# Agenda for **56<sup>th</sup> PCC meeting**

**Date: 22.06.2017**  
**Eastern Regional Power Committee**  
**14, Golf Club Road, Tollygunge**  
**Kolkata: 700 033**

## AGENDA FOR 56<sup>TH</sup> PROTECTION SUB-COMMITTEE MEETING TO BE HELD AT ERPC, KOLKATA ON 22.06.2017 (THURSDAY) AT 11:00 HOURS

#### ITEM NO. B.1: Disturbance at 220 kV Balasore S/s (OPTCL) on 03-05-17 at 17:15 hrs.

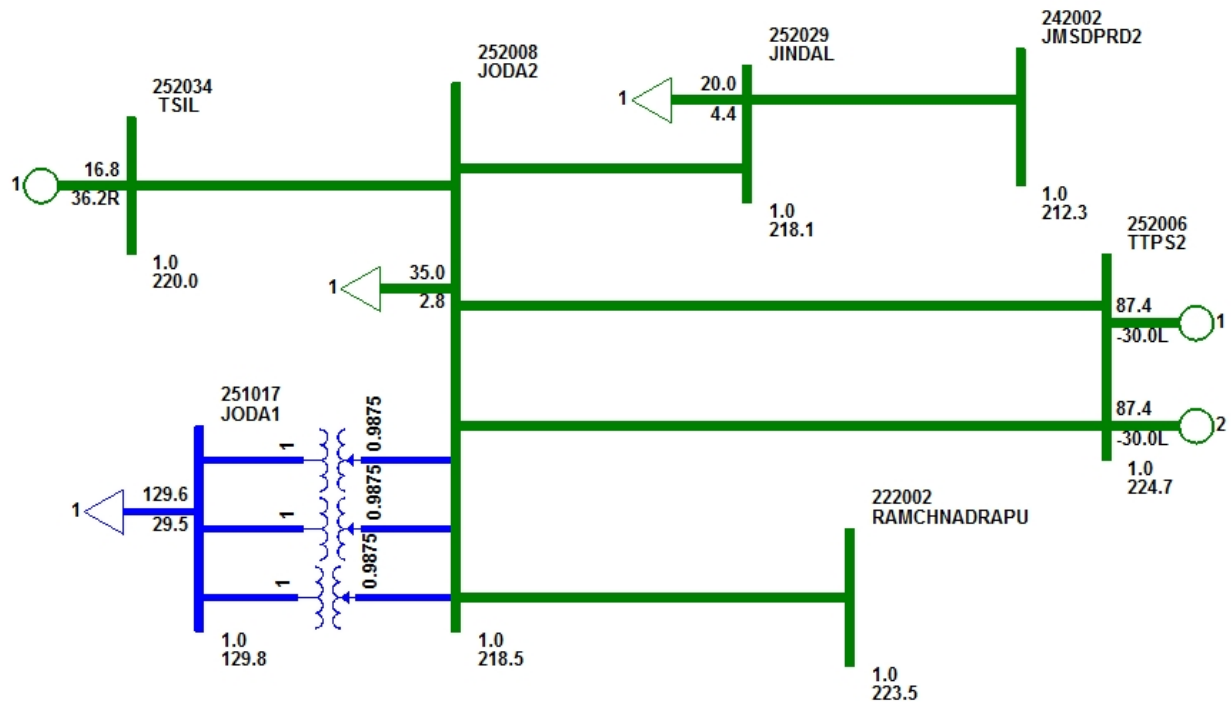
- Reason for non-operation of ckt breaker of 220 Baripada – Balasore S/C at Baripada end
- As per PMU data, fault clearing time is 450 ms.
- How 220 kV Balasore – Bhadrak S/C tripped from Balasore on reverse zone within 400 ms?
- How New Dubri end tripped on zone 3 within 400 ms?

#### ITEM NO. B.2: Disturbance at 220 kV Joda and Ramchandrapur S/s on 13-05-17 at 22:08 hrs.

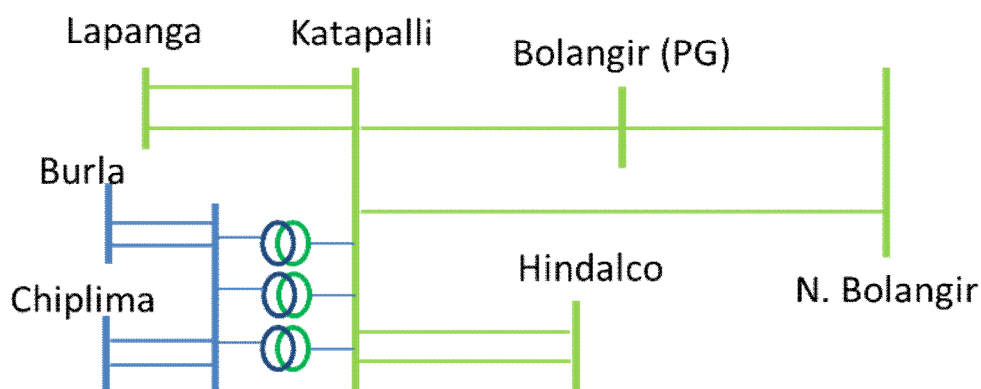
- As per PMU data, fault clearing time is 450 ms.
- Tripping of 220 kV Ramchandrapur – Joda S/C from Ramchandrapur end
- Operation of O/C protection of 220 kV Jamshedpur (DVC) – JSPL S/c from Jamshedpur end may be explained. As per SCADA data, power flow through this line was well under maximum loading limit.
- Tripping of 220KV Joda-TSIL line from TSIL on vector shift relay

**ITEM NO. B.9: Disturbance at 400 kV Sasaram S/s on 29-05-17 at 13:38 hrs.**

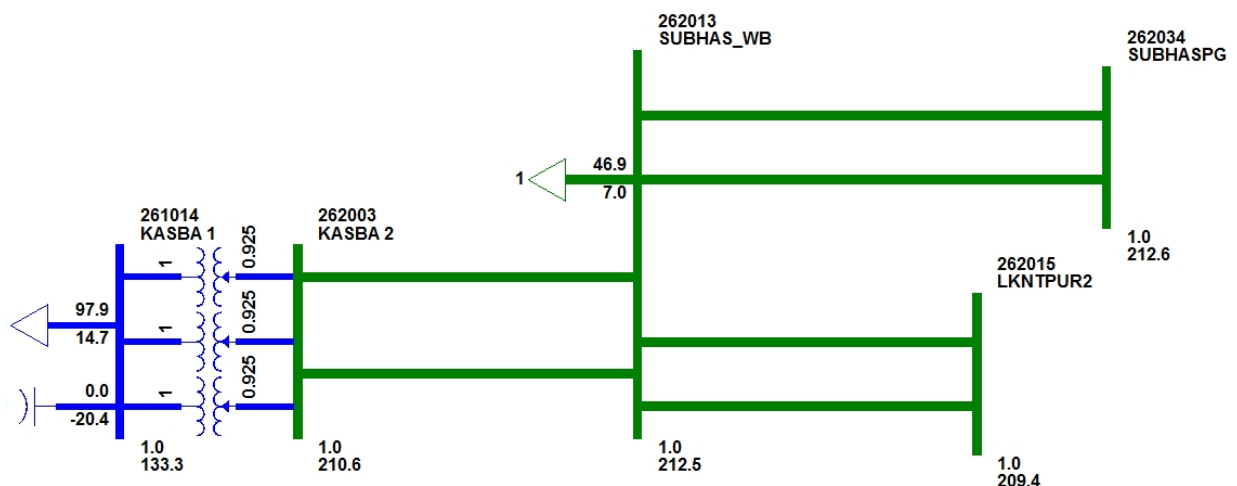
- Time & reason for tripping of 400 kV Biharshariff – Sasaram – I may be shared.
- As per SCADA data, Circuit I tripped 50 sec after tripping of circuit II. But as per PMU data, voltage at Sasaram & Patna became low at 7 sec after the tripping of Circuit II (But Biharshariff PMU voltage was unchanged).

**ITEM NO. B.10: Disturbance at 220 kV Subashgram S/s (WB) on 17-05-17 at 06:28 hrs.****1. Single line diagram: Submitted**

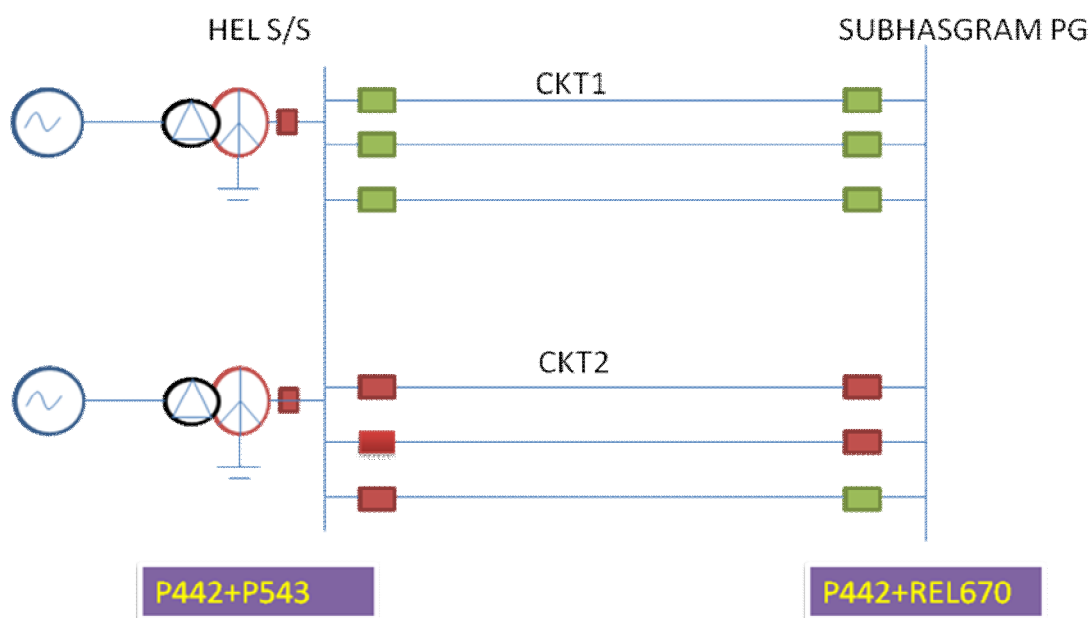
- Reason for not clearing the fault from Subhasgram(WB)
- Differential protection may be implemented for 220 kV Subhasgram (PG) – Subhasgram(WB) D/C line

**ITEM NO. B.15: Disturbance at 132 kV Jamui (BSPTCL) on 25-05-17 at 13:28 hrs.**

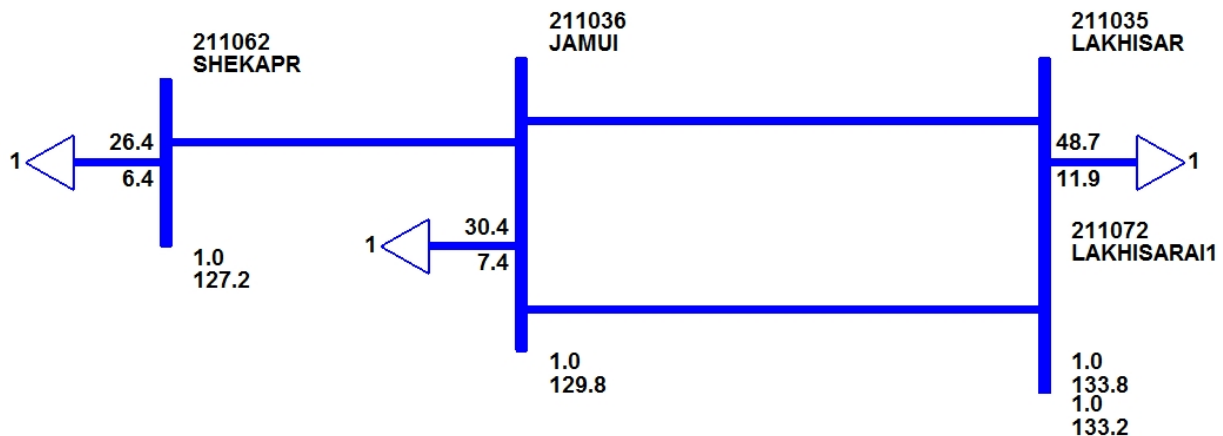
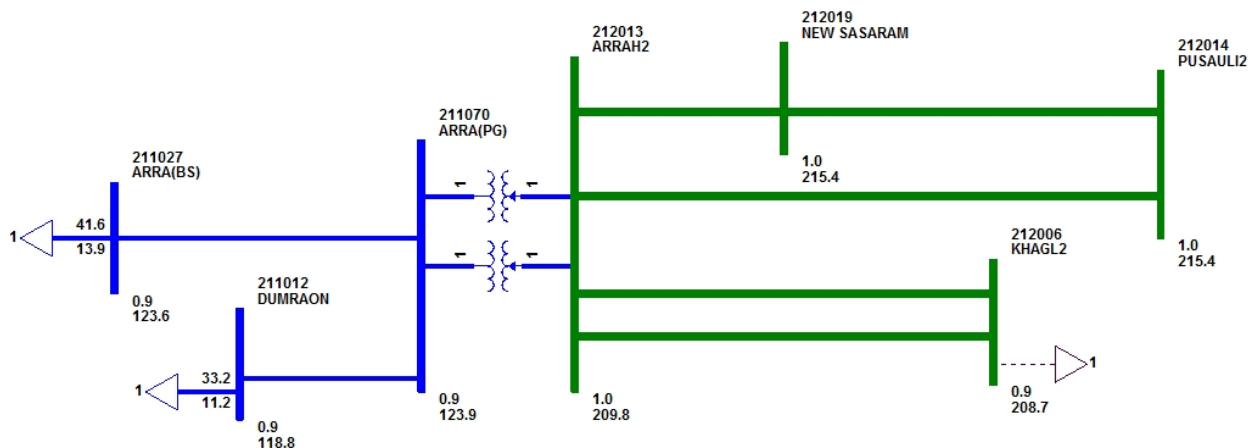
- Tripping of 132kV Jamui-Lakhisarai D/C line from Jamui end
- CT polarity of Jamui end needs to be verified

## Analysis of the tripping of 400 kV Jharsuguda – IBEUL - II at 19:50 hrs on 26-05-17

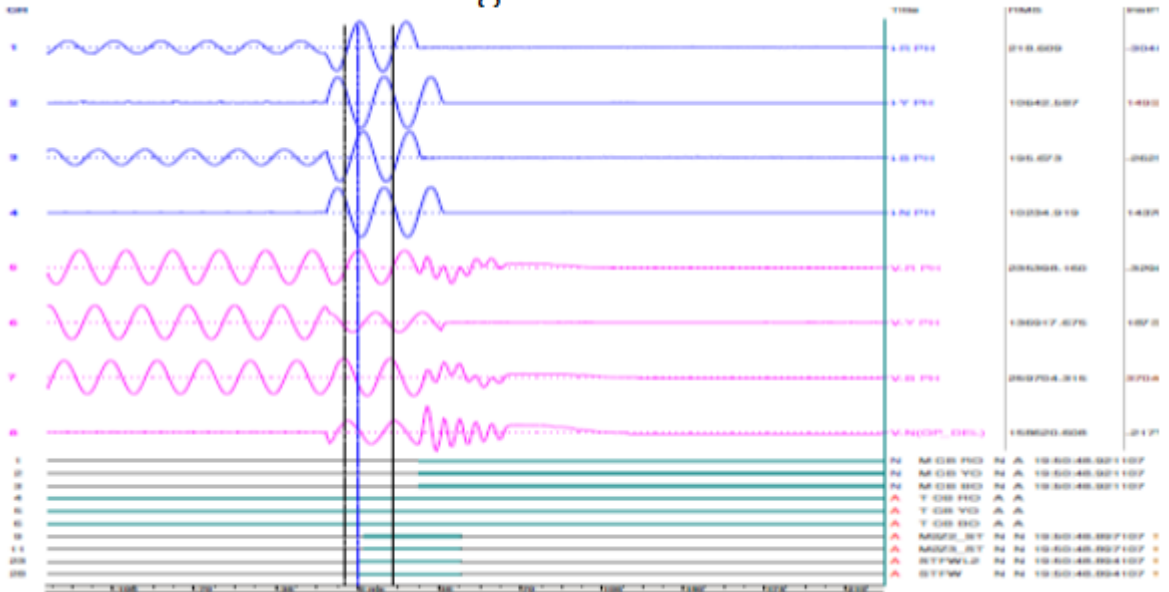
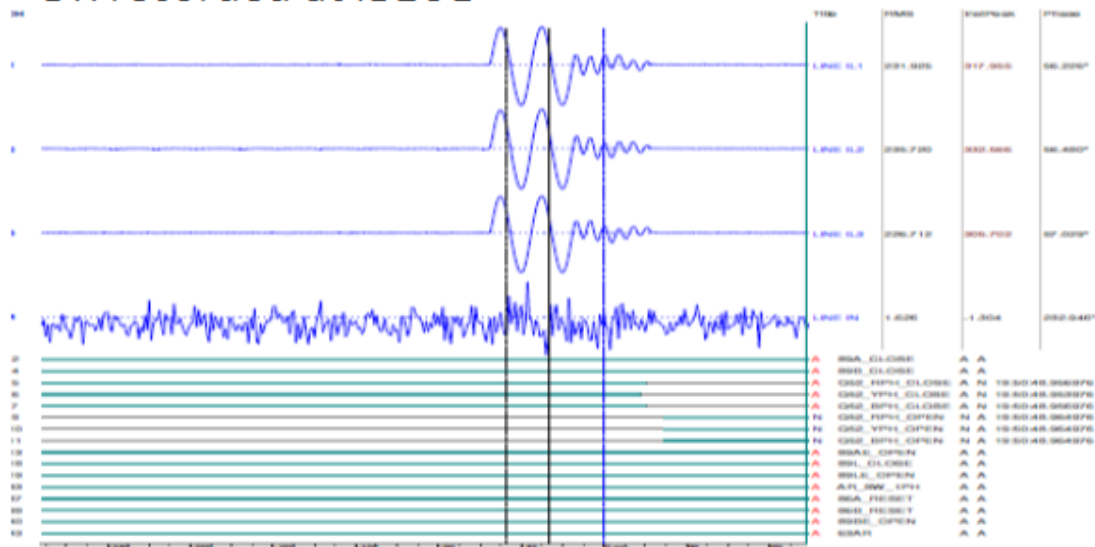
Pre-fault current: 55-60A in each phase; Post fault current: 200 A in R & B phases and 10.5 kA in Y phase

Pre-fault current: 1.5 - 2A in each phase; Post fault current: 305-320A in each phase
